**From:** McLellan, Judith  
**Sent:** Wednesday, February 27, 2013 3:27 PM  
**To:** ArevaEPRDCPEm Resource  
**Subject:** FW: Response to U.S. EPR Design Certification Application RAI No. 294, FSAR Ch. 10, Supplement 23  
**Attachments:** RAI 294 Response Supplement 23 US EPR DC.pdf  
**Importance:** High

**Questions 10.02.03-17, 10.02.03-20 and 10.02.03-23**

**QUESTIONS for Component Integrity, Performance, and Testing Branch 1  
(AP1000/EPR Projects) (CIB1)**

**Figure 10.02.03-20-1—Initial Defect  $a_0$**

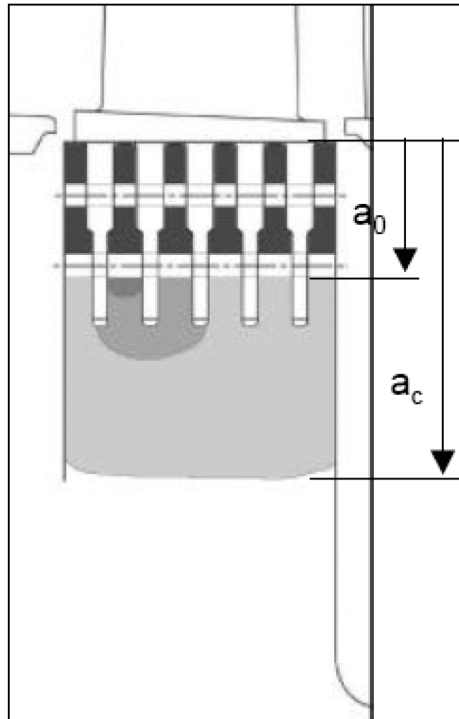
The applicant's response to RAI No. 100, Question 10.02.03-6, provided that, since these are weld rotors, keyways are not used as in shrunk-on turbine rotor discs. However, in response to RAI No. 100, Question 10.02.03-8, the applicant stated that holes are drilled for the pins used to fix the moving blades to the turbine rotors. These holes are drilled once the blades are assembled to the turbine rotor and, therefore, a surface examination is not performed. However, to account for not performing a magnetic-particle or liquid penetrant examination of the holes, the turbine missile analysis will account for this by considering a potential initial defect in the turbine rotor at the zero point. In addition, ultrasonic examination is performed on the forged pieces. Also, there are no finished bores in this turbine design. Based on this information, the staff needs the following information to determine whether the integrity of the turbine rotor can be determined prior to service:

- a. Confirm this is a solid cored rotor (non-bored). If this is the case, provide the following:
  1. Discuss the method for obtaining, for the non-bored rotor, 100 percent ultrasonic inspection in accordance with the FSAR Tier 2, Sections 10.2.3.5 and 10.2.3.6, since there is no bore to gain access to perform the ultrasonic inspection.

- c. The "zero point" discussed in the Response to RAI 100, Question 10.02.03-8 means that at  $t = 0$ , an initial defect  $a_0$  (see Figure 10.02.03-20-1—Initial Defect  $a_0$ ) in the axial radial plane, which includes the discs fingers and lies from the disc outer diameter to the bottom of the inner pin hole, is taken into account in the missile analysis.

**Figure 10.02.03-20-3—Radial, Tangential and Axial, or Longitudinal Locations**

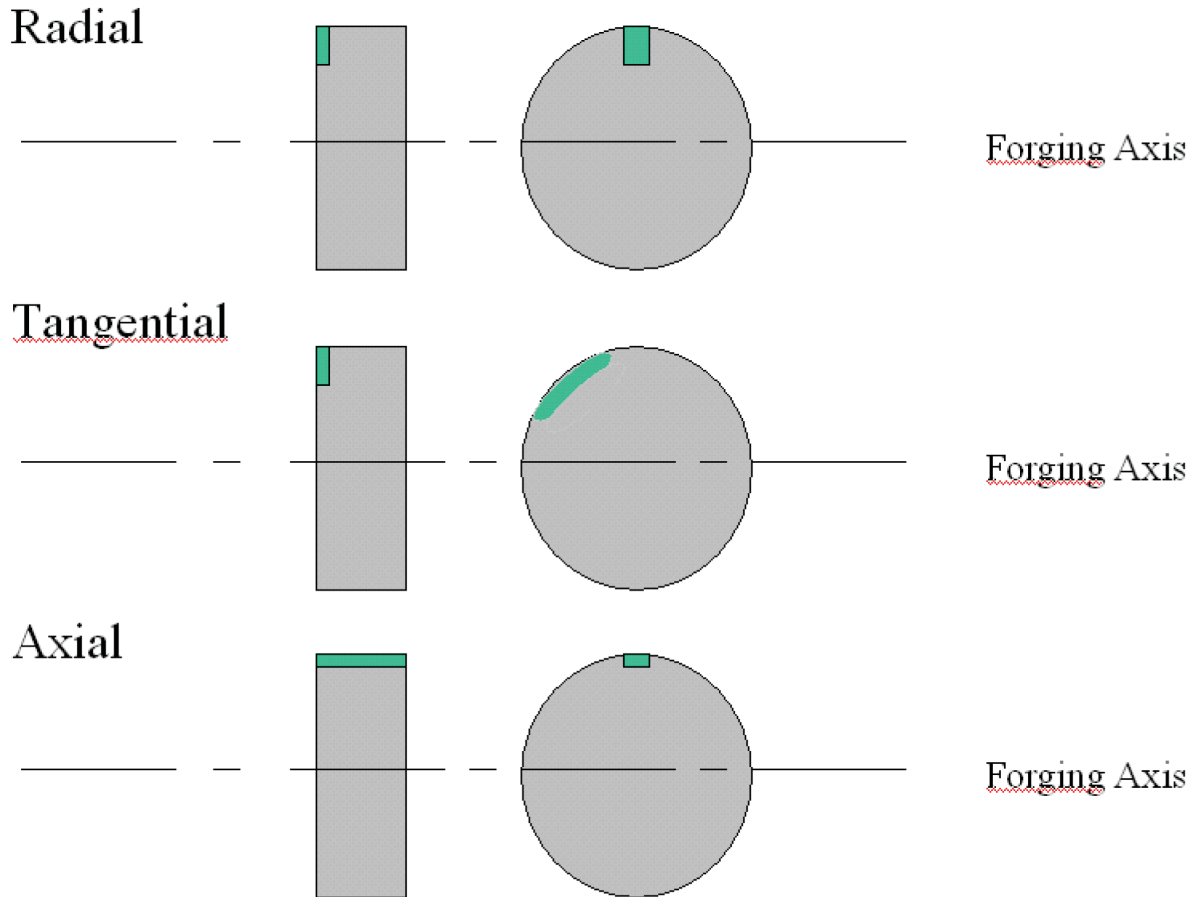
2. Typically, each fabricated rotor has destructive testing performed at various locations to ensure homogeneity and acceptable material properties. Justify that the material properties for each rotor fabricated will have the required material properties and homogeneity throughout the forged rotor, including the interior, which is normally bored out. Also, provide any supporting evaluations or tests.

These are shown in Figure 10.02.03-20-3—Radial, Tangential and Axial or Longitudinal Locations. The number of test pieces and their various locations confirms that each rotor has the required material properties and homogeneity throughout the forged rotor. COL Items 10.2-2 and 10.2-3 in U.S. EPR FSAR Tier 2, Table 1.8-2—U.S. EPR Combined License Information Items require the COL applicant to provide information on material properties and rotor specimen test data, respectively.
